**SUBDIVISION, PLANNED UNIT DEVELOPMENT,
PLANNING APPROVAL, ZONING AMENDMENT,
& SIDEWALK WAIVER REQUEST
STAFF REPORT**

Date: February 17, 2010

<u>APPLICANT NAME</u>	David L. Pitts
<u>SUBDIVISION NAME</u>	Whisper Oak Subdivision
<u>DEVELOPMENT NAME</u>	Whisper Oak Mobile Home Park
<u>LOCATION</u>	4512 Higgins Road (North side of Higgins Road, 215'± West of Shipyard Road)
<u>CITY COUNCIL DISTRICT</u>	Council District 4
<u>PRESENT ZONING</u>	R-1, Single-Family Residential District
<u>PROPOSED ZONING</u>	R-3, Multiple-Family Residential District
<u>AREA OF PROPERTY</u>	2.7 Acres ±
<u>CONTEMPLATED USE</u>	Subdivision Approval to create one legal lot of record from two existing metes and bounds parcels; Planned Unit Development and Planning Approval to allow a mobile home park with 22 mobile home spaces and one apartment building with gravel accessways and parking, rezoning from R-1 to R-3 to allow the mobile home park, and waiver of construction of a sidewalk along Higgins Road. It should be noted, however, that any use permitted in the proposed district would be allowed at this location if the zoning is changed. Furthermore, the Planning Commission may consider zoning classifications

SITE PLAN

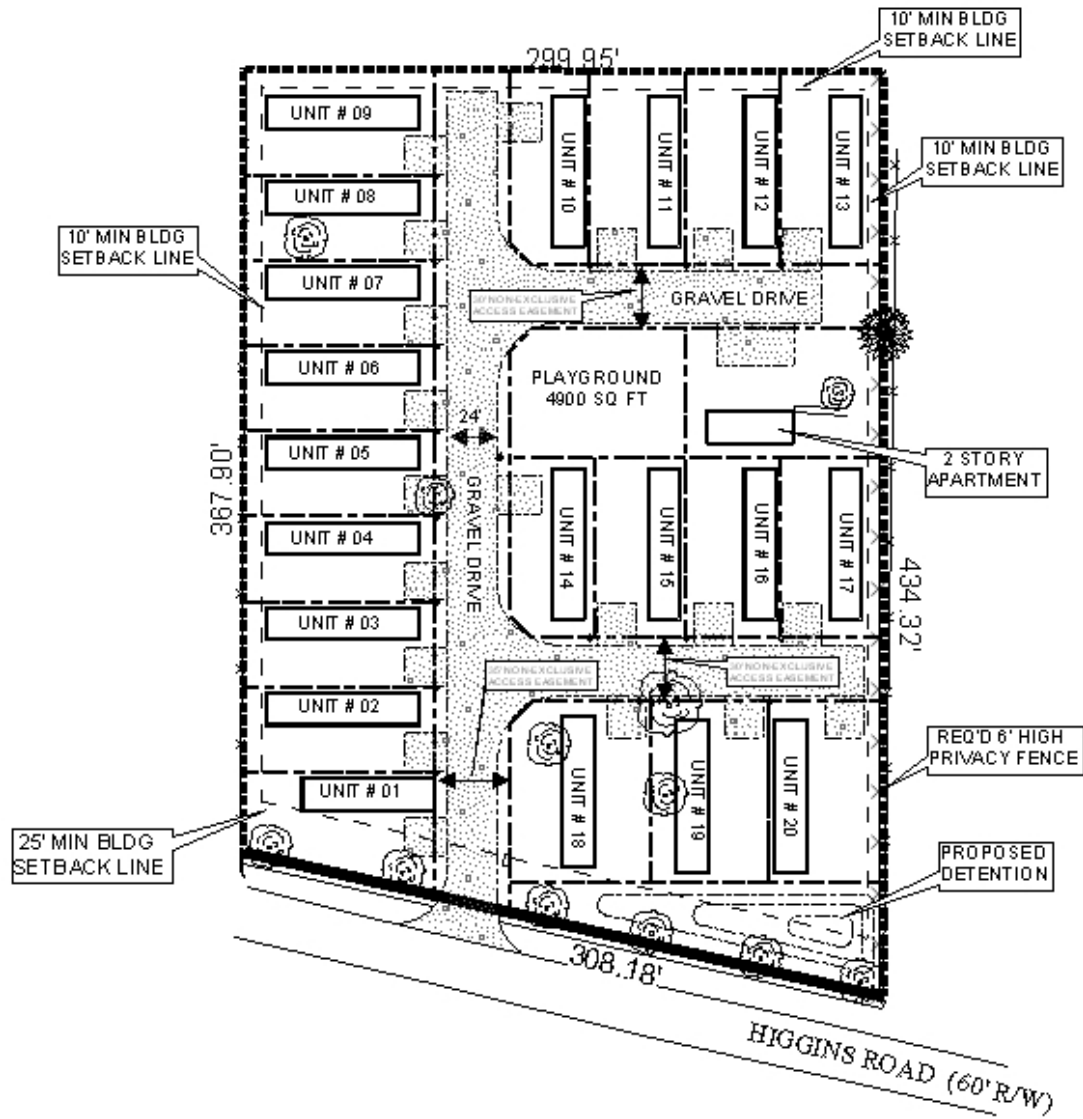
Regarding the lot layouts, Lots 1 and 21 appear to show the mobile home location area partially within the 25-foot minimum building setback line. No part of the mobile home location area should be located within the building setback. Also, regarding the size of each mobile home lot, Section 37-53 of the Mobile City Code requires a minimum lot size of 3,200 square feet for each mobile home lot. Area sizes for the lots are not shown, however, it appears that some lots may not meet this requirement. As such, each lot's size should be depicted to ensure that each meets the minimum size requirement.

Regarding access, the site plan depicts access as being via 20-foot wide gravel drives. The minimum size for two way accessways is 24 feet in width, and all accessways must be paved with asphalt or concrete. Additionally, parking of a sufficient number is depicted, however, the parking is depicted as being gravel; this should be revised to show the parking as asphalt or concrete.

The site plan is depicting an 8-foot setback to the East. The property to the East is developed as and zoned Single-Family Residential. As such, a 10-foot setback would be required to comply with buffering requirements. Additionally, no buffer is depicted, and, at a minimum, a privacy fence compliant with Section 64-4.D.1. should be provided.

It should be noted that Chapter 37 of the Mobile City Code sets out several design requirements for mobile home parks, and, as this application proposes substantial changes to the site, the provisions of Chapter 37 apply. Specifically, the site plan needs to show the following:

- Section 37-56: a playground common area surrounded by a fence or a wall of at least 4 feet in height containing 150 square feet for each mobile home lot
- Section 37-57: a dedicated patio area of at least 180 square feet on each lot, surfaced with rigid impervious pavement

The site plan does not indicate compliance with the tree and landscaping requirements of the zoning ordinance. Full compliance should be required.

The revised site plan indicates that all of the mobile home sites have been modified to remove all building sites from the setback areas, and the accessways have been increased to 24 feet in width. The applicant has, additionally, removed two of the mobile home lots to be able to maintain the required size of the lot (3,200 square feet), and the applicant has also indicated the common space/playground area as required in Section 37-56 of the Mobile City Code. The site plan also now indicates the required buffer located on the east side of the property, and the landscaping plan also appears to comply with the requirements of the Zoning Ordinance.

The site plan does not indicate the dedicated patio area of at least 180 square feet on each lot, surfaced with rigid impervious pavement as required by Section 37-57 of the Mobile City Code. Chapter 37 gives the Planning Commission the authority to waive this section of the Chapter, and the applicant has requested such a waiver. The applicant states that they wish to construct elevated wooden patio decks "because it would provide better use to the elevated mobile homes." This modification seems reasonable, however, the decks should be shown on the site plan and a stipulation be placed on the approval stating that the wooden decks must meet all applicable building codes and be maintained perpetually to ensure safety.

The applicant is also continuing to indicate gravel driveways and parking areas. The applicant has submitted an application to the Board of Adjustment for the gravel surfacing, and, if the PUD is approved, it should be subject to Board of Adjustment approval with the stipulation that if it is not approved by the Board, then concrete or asphalt surfacing would be required.

- 1) revision of the site plan to remove all mobile home sites from the 25-foot minimum building setback line;
- 2) revision of the site plan to depict all two way accessways as being at least 24 feet in width;

- 3) revision of the site plan to depict all accessways and parking as either asphalt or concrete;
- 4) revision of the site plan, and redesign, as necessary, to depict all mobile lots as being at least 3,200 square feet in area;

- 5) revision of the site plan to depict the required playground/common area as required in Section 37-56 of the Mobile City Code;
- 6) revision of the site plan to depict the dedicated patio area as required in Section 37-57 of the Mobile City Code;

- 7) revision of the site plan to depict the 10-foot required setback and buffer area where the site abuts residentially zoned property as well as a privacy fence in compliance with Section 64-4.D.1. of the Zoning Ordinance; and

- 8) submittal of a landscape plan showing full compliance with the tree planting and landscaping area requirements of the Zoning Ordinance.

SIDEWALK CROSS-SECTION

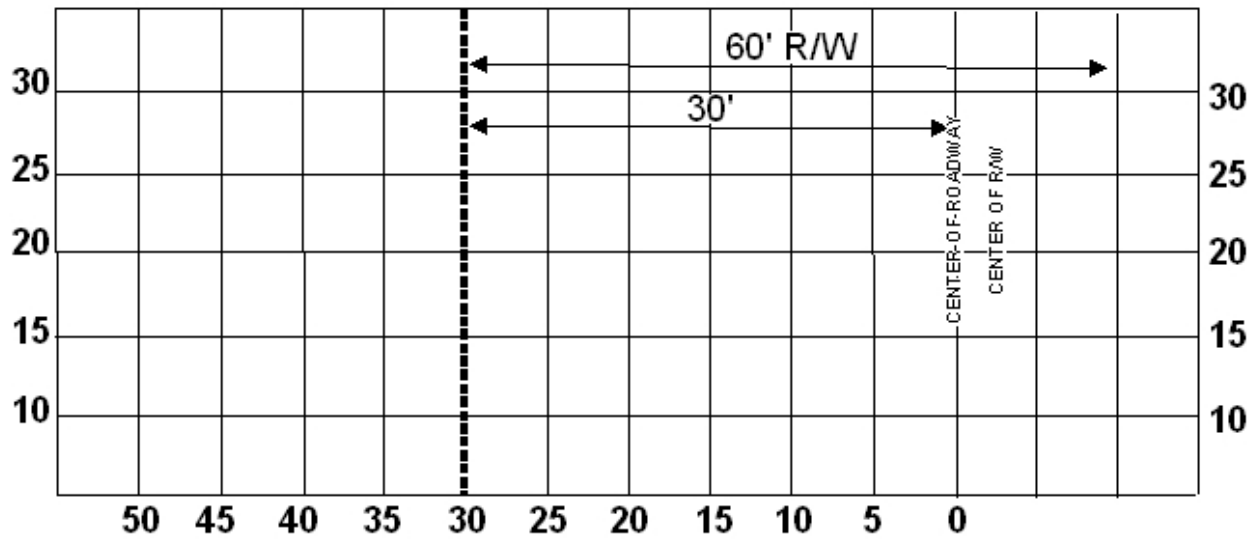
Lastly, regarding the sidewalk waiver request, city engineering has determined that construction of a sidewalk is not practical due to open drainage and insufficient right-of-way. As such, the sidewalk waiver should be approved.

Sidewalk Waiver Request: *The request for a Sidewalk Waiver is recommended for approval.*
